**LEBANON PLANNING BOARD
JUNE 13, 2022 - 6:30 PM
COUNCIL CHAMBERS, CITY HALL OR
REMOTE VIA VIRTUAL PLATFORM
LEBANONNH.GOV/LIVE**

**Recreo, LLC,
2 Mascoma Street
(Tax Map 91, Lots 254),
Zoned LD
PB2022-17-SPR**

2 MASCOMA STREET REDEVELOPMENT

Site Plan Review for a proposed phased expansion of the DHMC Outpatient Surgery Center

① EAST WEST BUILDING SECTION LOOKING NORTH - ROOF ACCESS
1/4" = 1'-0"

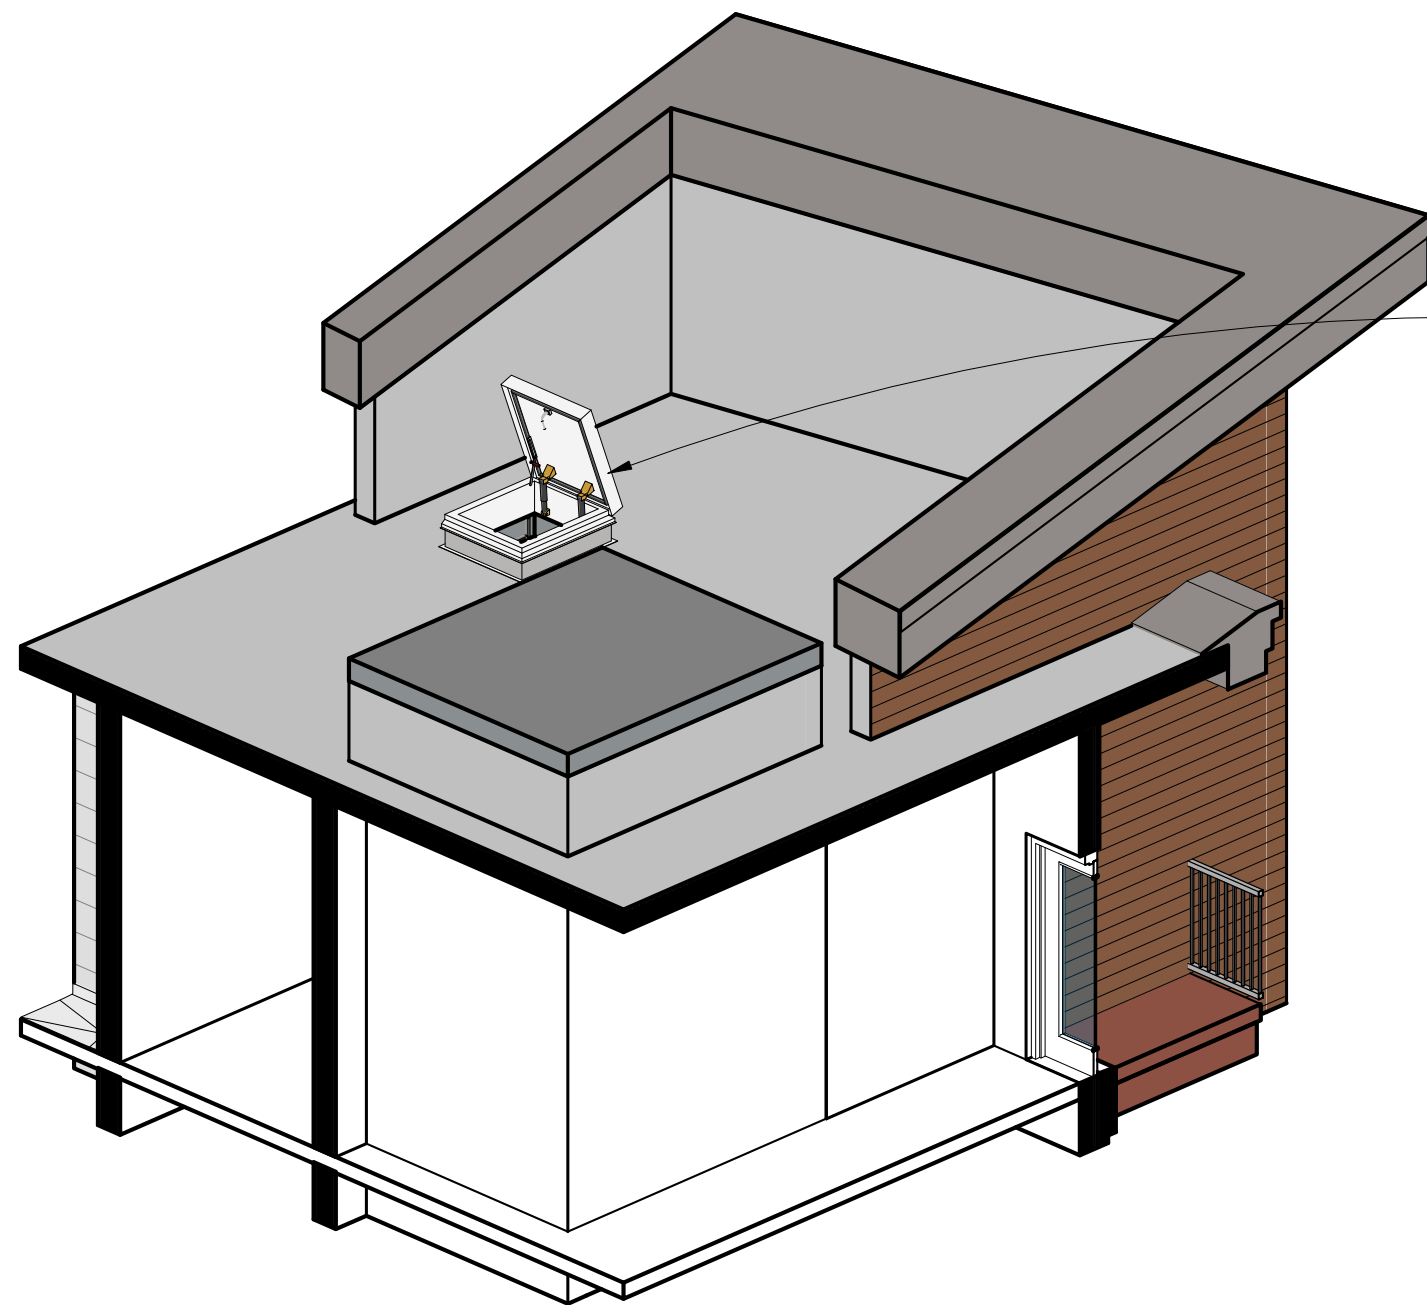
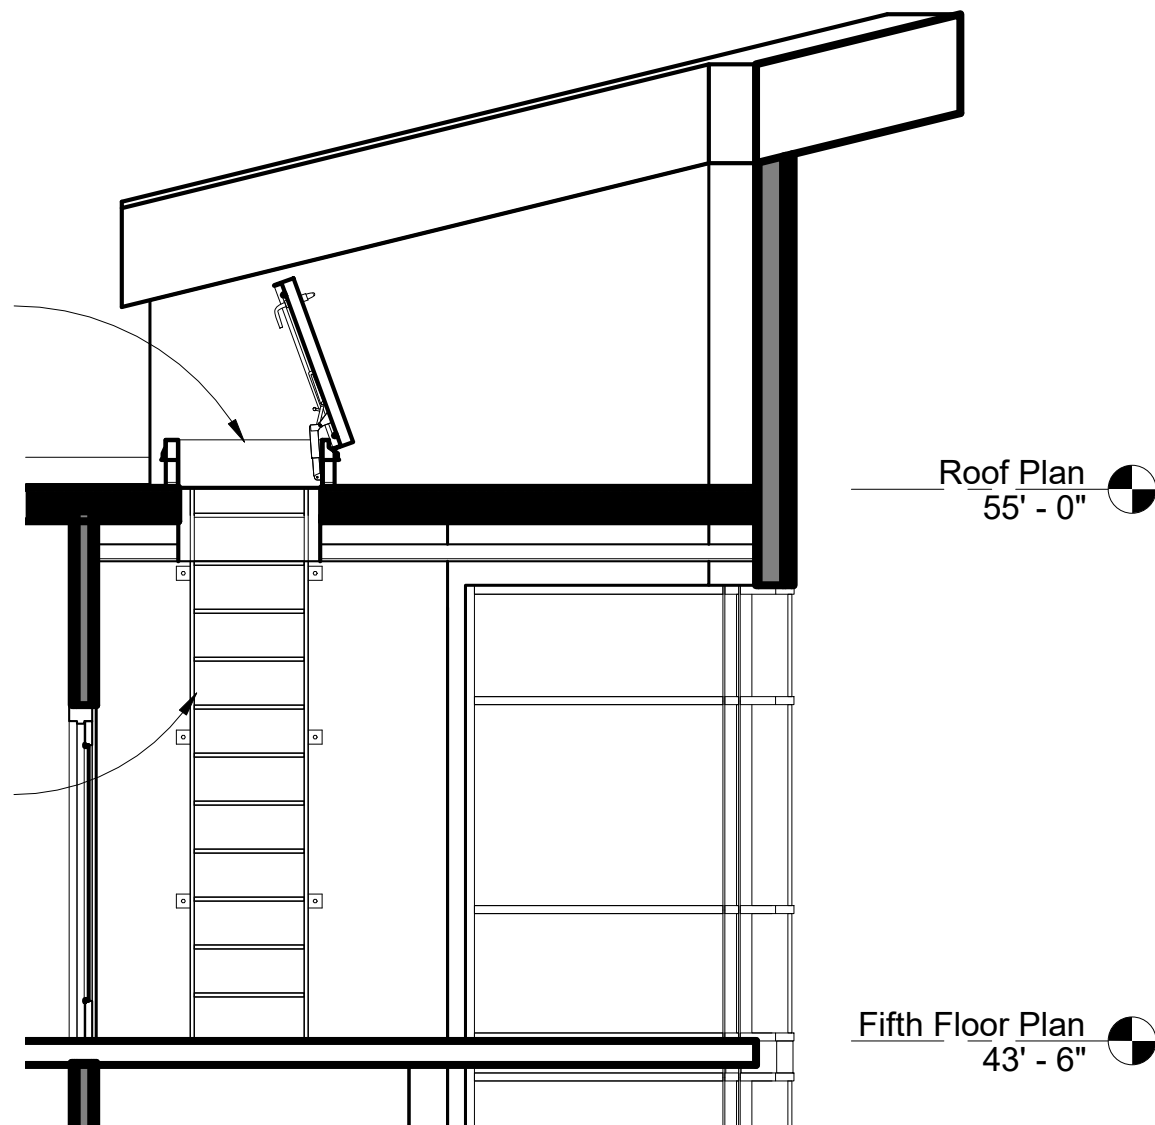
Exhibit Drawing A-23: Shows a detail of the top of the tower and roof access to Building 1. Note that the tower is “hollow”, formed only by parapet walls.

L4.00

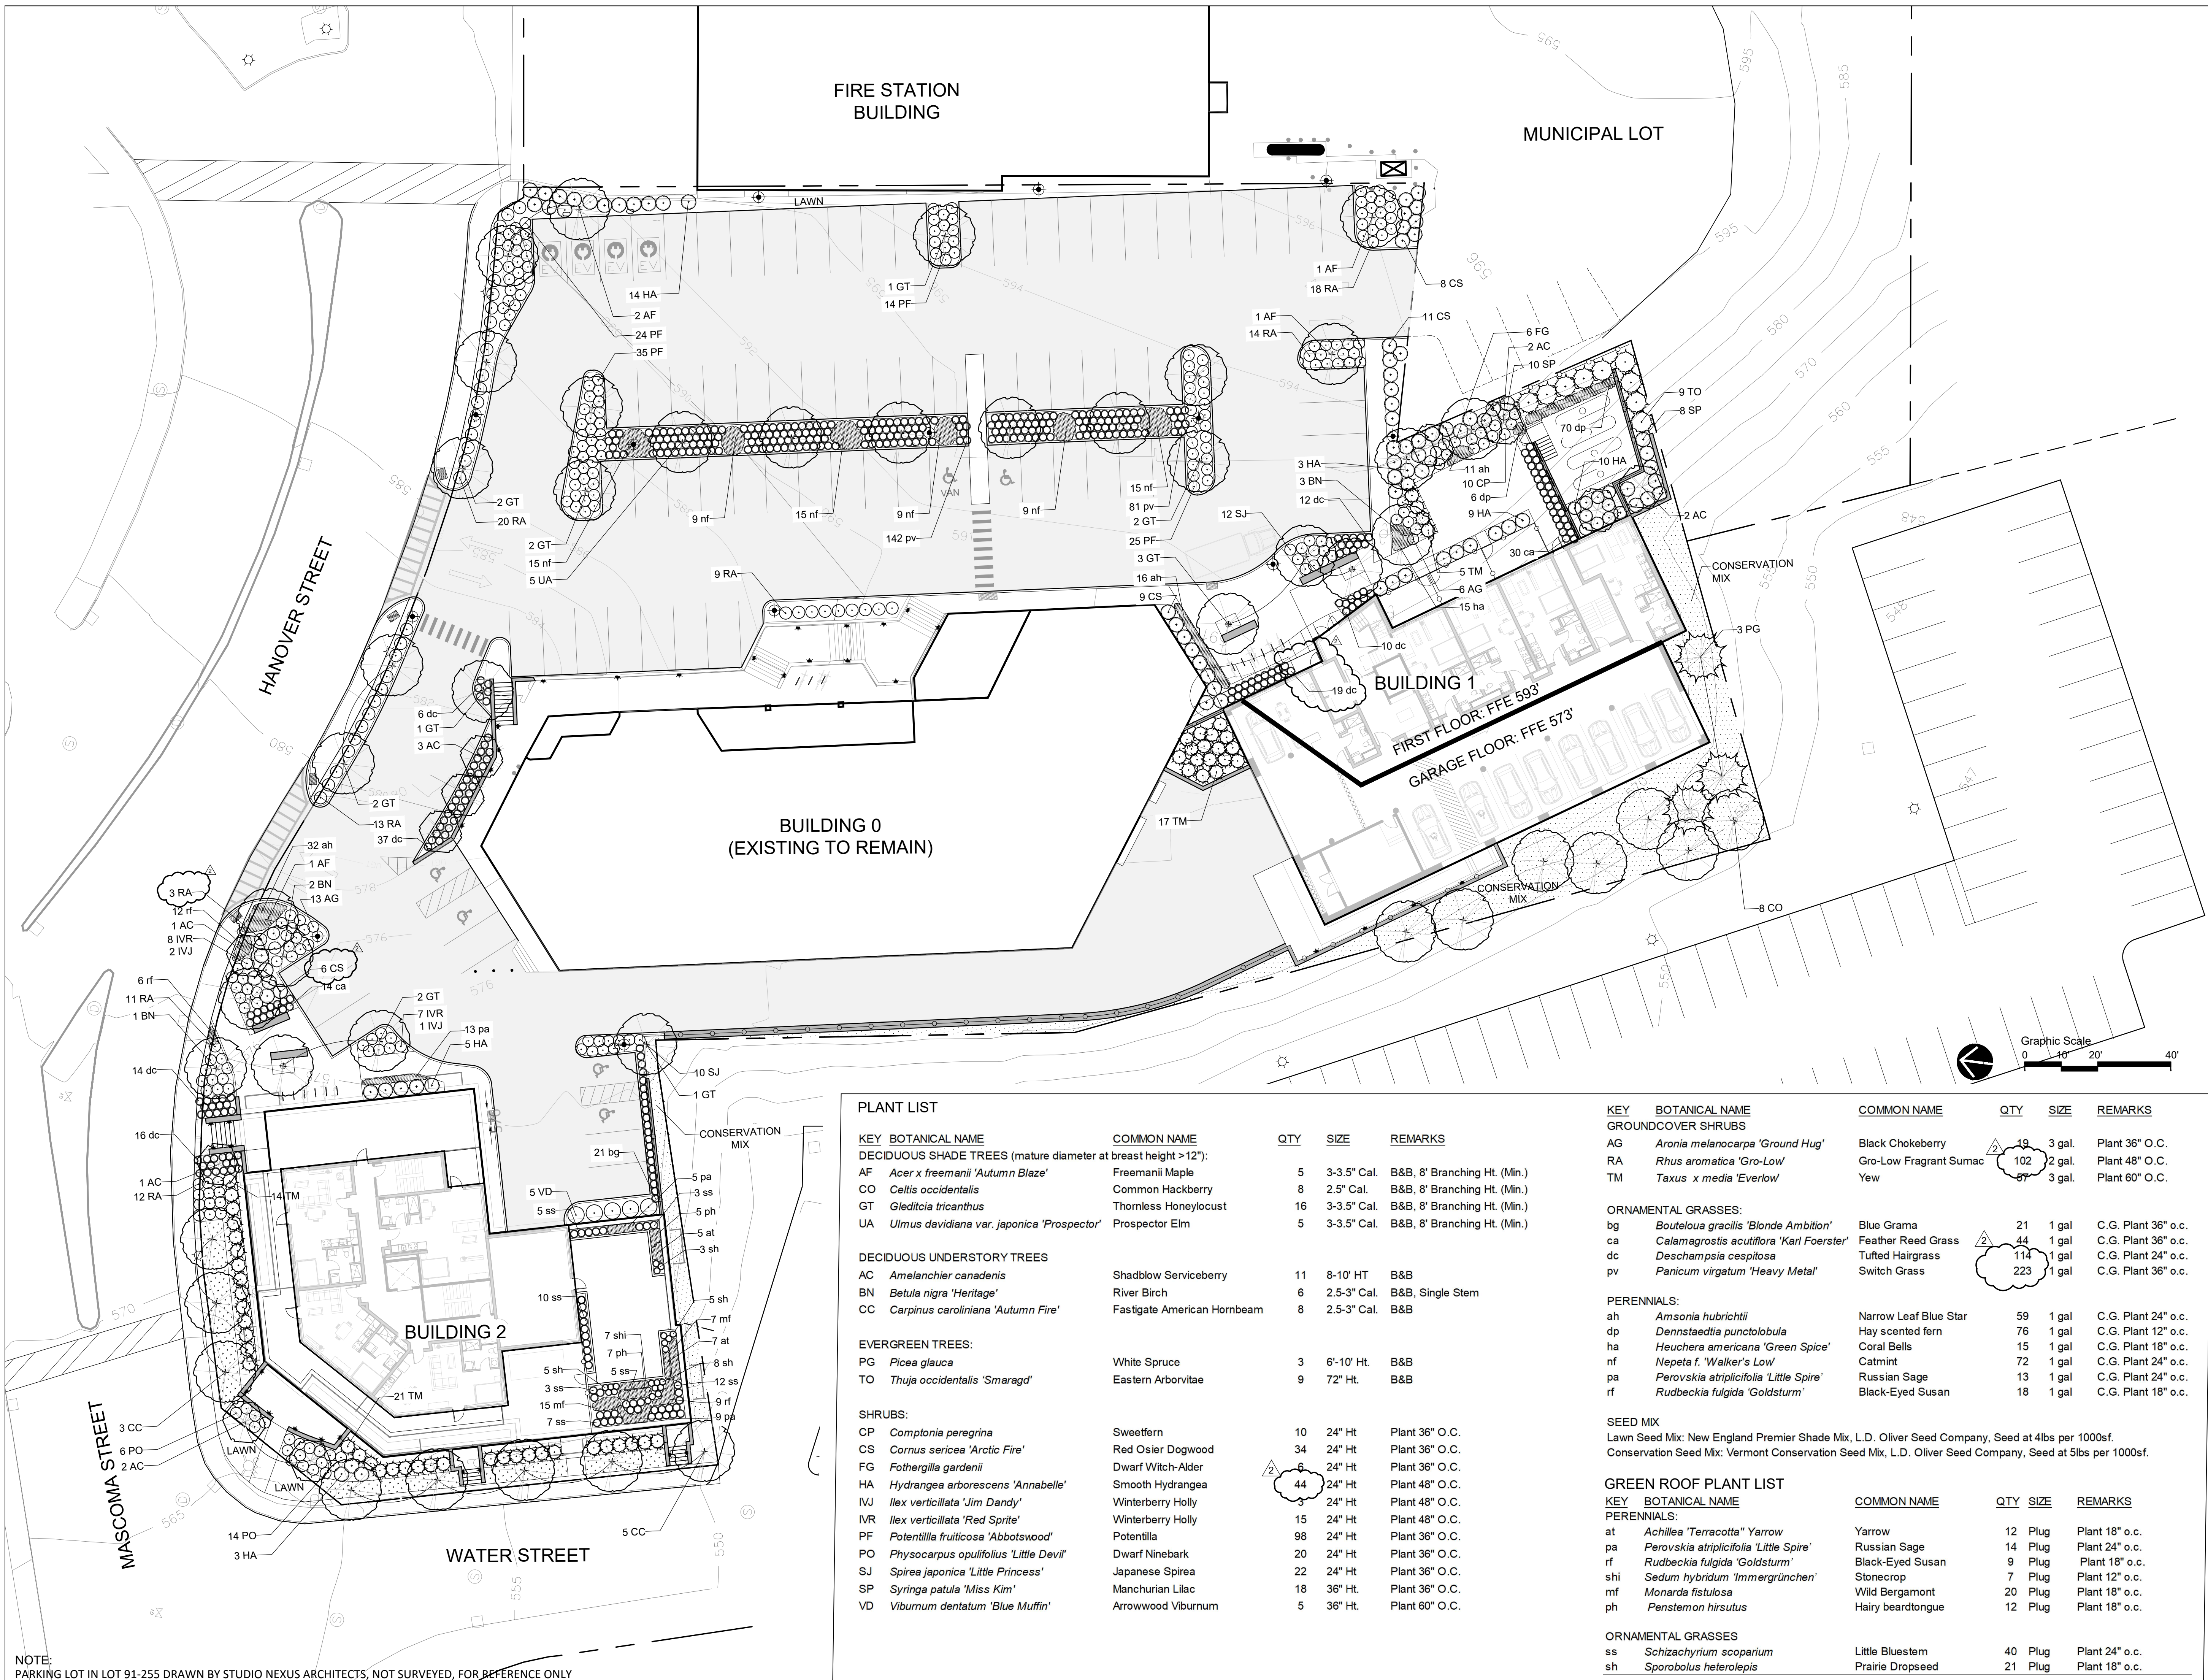
Plan Set Drawing L4.00: Shows two minor revisions—the first cuts back several feet of landscaping at the main entry to Building 1 to satisfy Fire Department requirements that there be clear, landscape-free access to the standpipe and fire department connection; the second replaces some plantings at the westernmost access to the site to improve vehicle visibility.

No.	Description	Date
1	Revision 1	04/22/22
2	Shortened bed - plant changes	06/02/22
